Sheringham Shoal and Dudgeon Offshore Wind Farm Extension Projects

Outline Cromer Shoal Chalk Beds (CSCB) Marine
Conservation Zone (MCZ) Cable Specification, Installation
and Monitoring Plan (CSIMP) (Revision B) (Clean)

Revision B

Document Reference: 9.7

Title: Figure 2 - Cromer Shoal Chalk Beds MCZ Protected Features

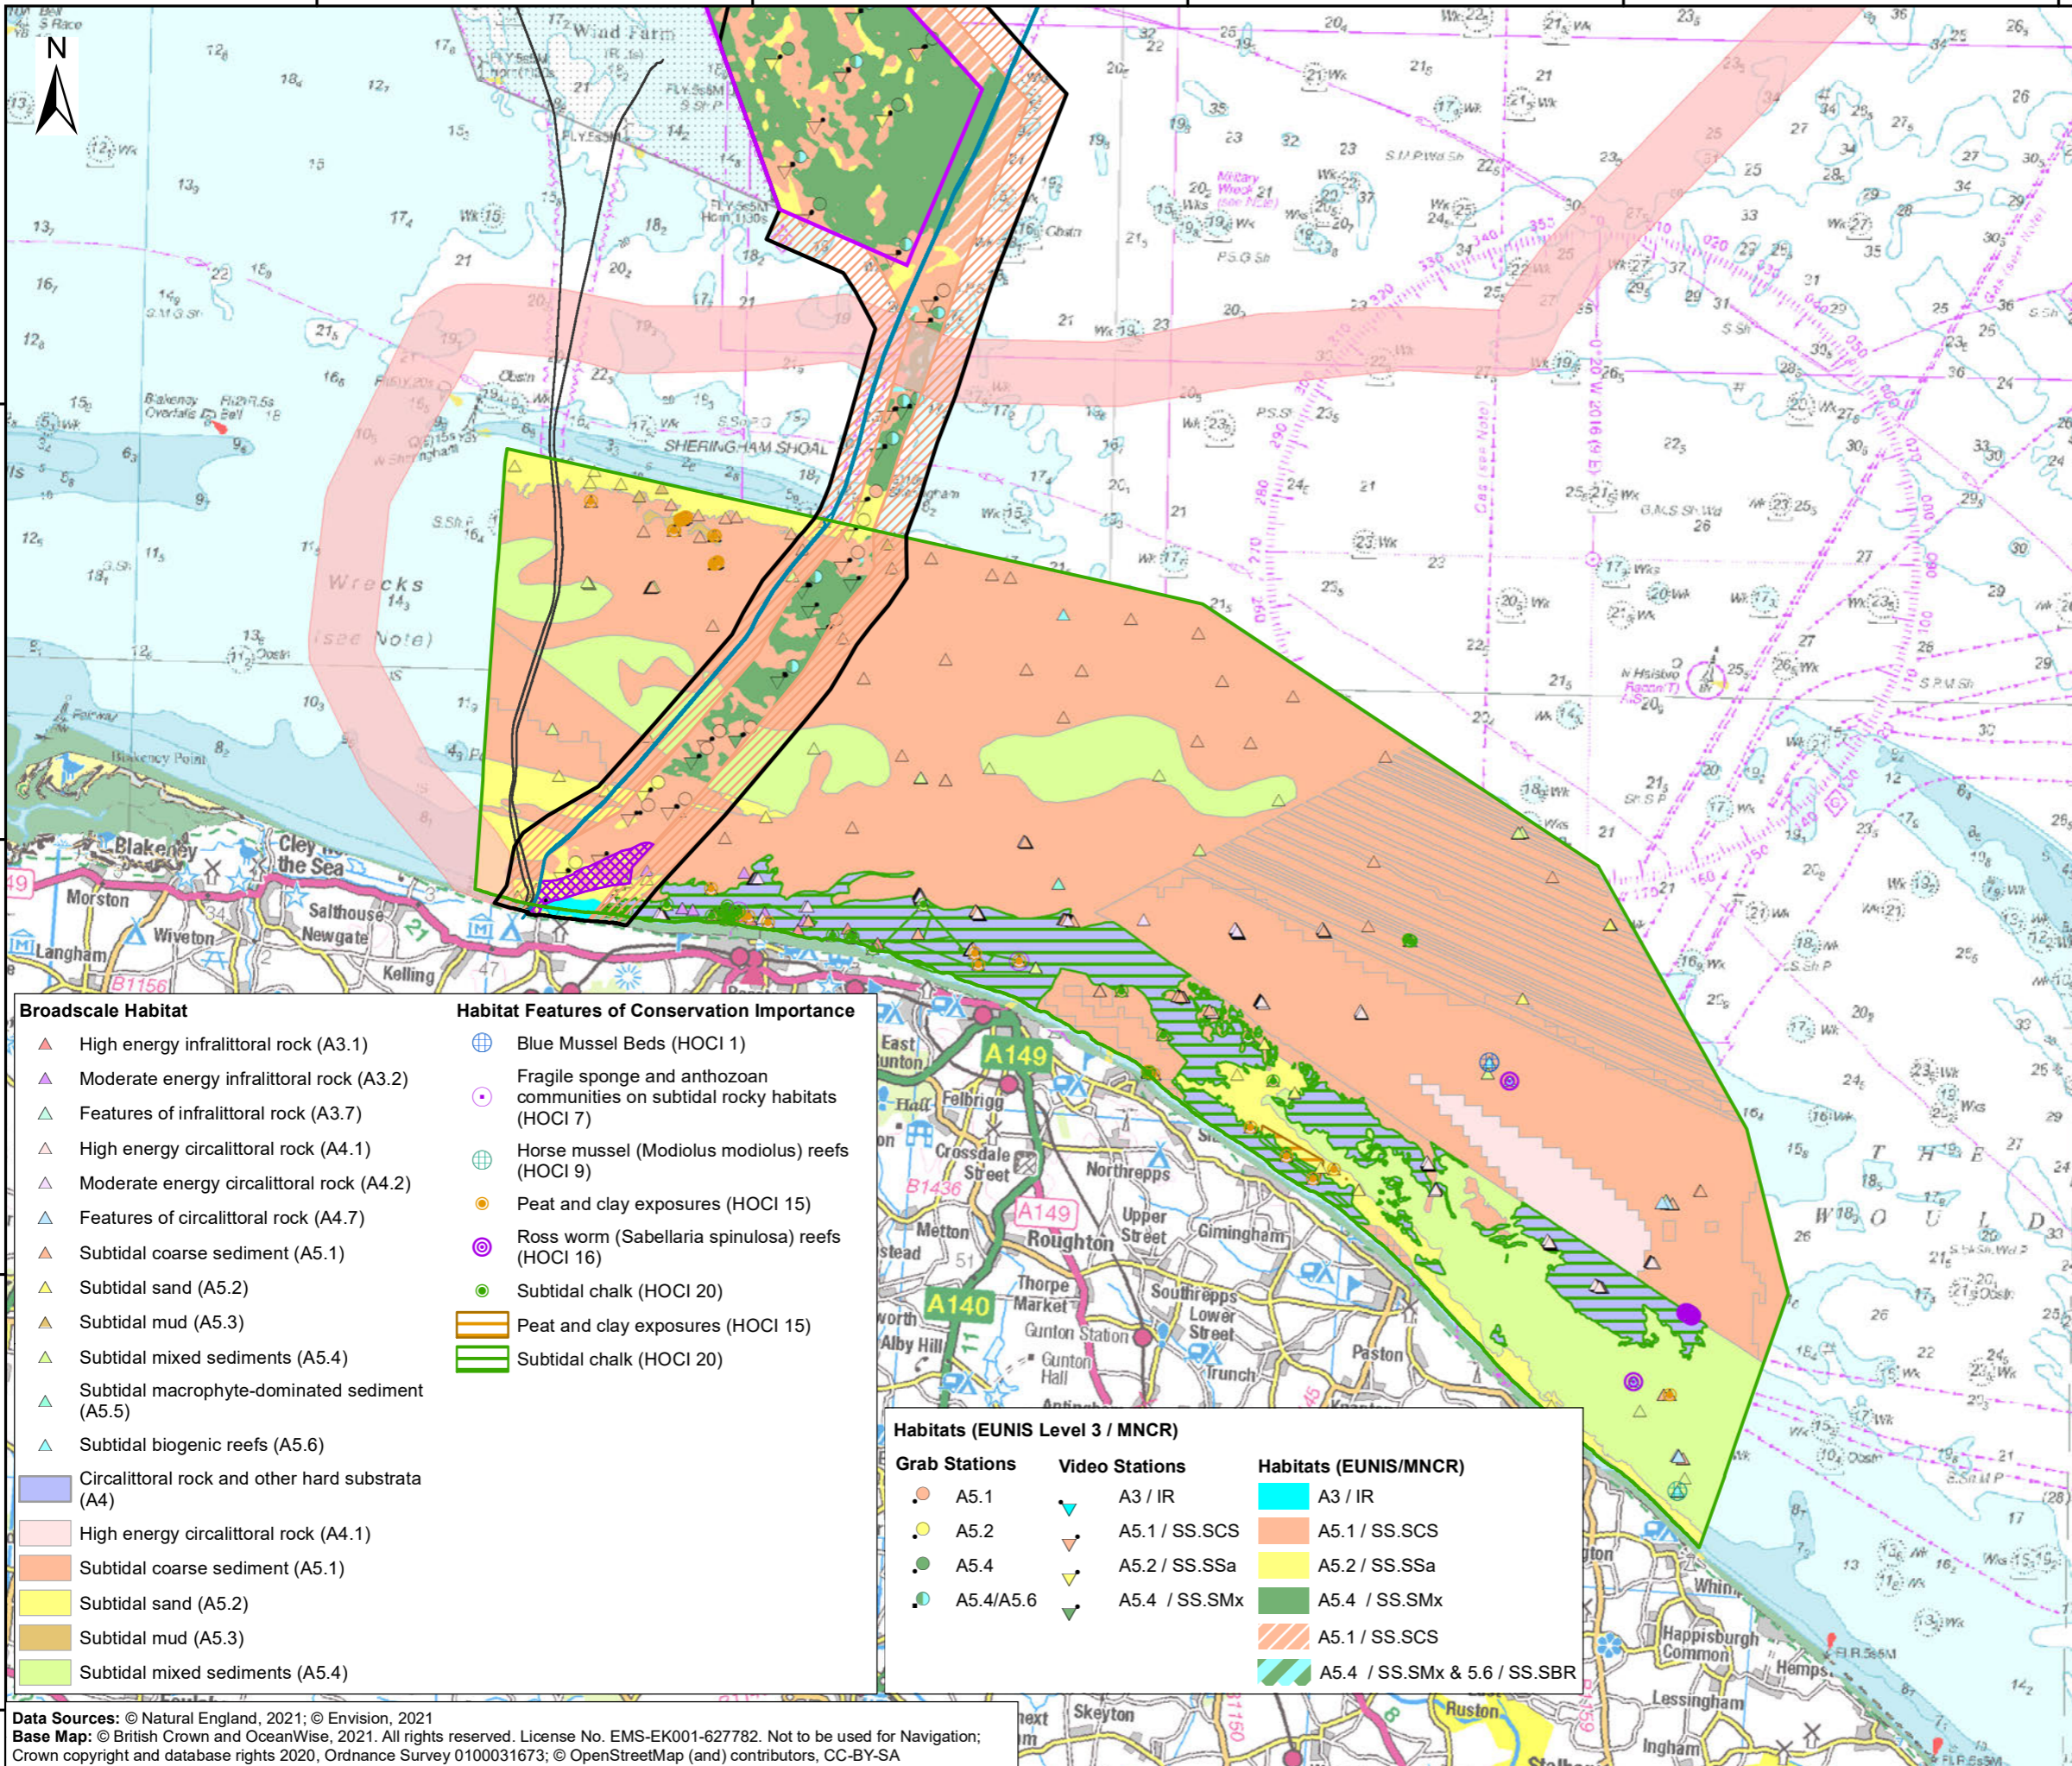
EIFCA	March 2022	Subtidal chalk extent shown in Figure 2 and 1-1 is limited to the A4 circalittoral rock feature, this is not consistent with NE's latest feature advice which shows subtidal chalk (HOCl 20) to be much more extensive. ¹	It was agreed at Sea bed ETG 2 following presentation of evidence contained in Appendix 6.2 Sedimentary Processes in the Cromer Shoal Chalk Beds MCZ (document reference 6.32.6.2) that sea bed sediments in the offshore export cable corridor within the CSCB MCZ are static, with the exception of Holocene sand / subtidal sand, which is mobile under some conditions. Therefore, the potential for subtidal chalk to be exposed in the future is restricted to the subtidal sand areas identified by the geophysical survey. Further information on the extent of the subtidal chalk FOCl is available in Section 7 of the Stage 1 CSCB MCZ Assessment (Revision B) (document reference 5.6).

Consultee	Date	Comment Received	Project Response
			In summary, survey data indicates that areas where there is potential for subtidal chalk to be exposed are of very limited extent within the offshore export cable corridor, and it is unknown if any such exposures would meet the criteria to be classified as the subtidal chalk habitat FOCI (e.g. criteria provided by Natural England for Hornsea Project Three (RPS, 2020), or how persistent they would be. Therefore the MCZA is based on the known locations of subtidal chalk restricted to the outcropping subtidal rock feature in the inshore area of the CSCB MCZ only.
EIFCA	March 2022	Will there be further consultation of the final CSIMP with engaged stakeholders in addition to the MMO and NE? This draft CSIMP includes several references to the ES which is not publicly available. Will there be further opportunity to comment when the ES is publicly available?	Following submission of the DCO application, EIFCA will have the opportunity to comment on any of the DCO application submission documents they so wish to respond to. In addition, this Outline CSCB MCZ CSIMP will be updated at the post consent stage in consultation with the MMO and other relevant consultees such as EIFCA.
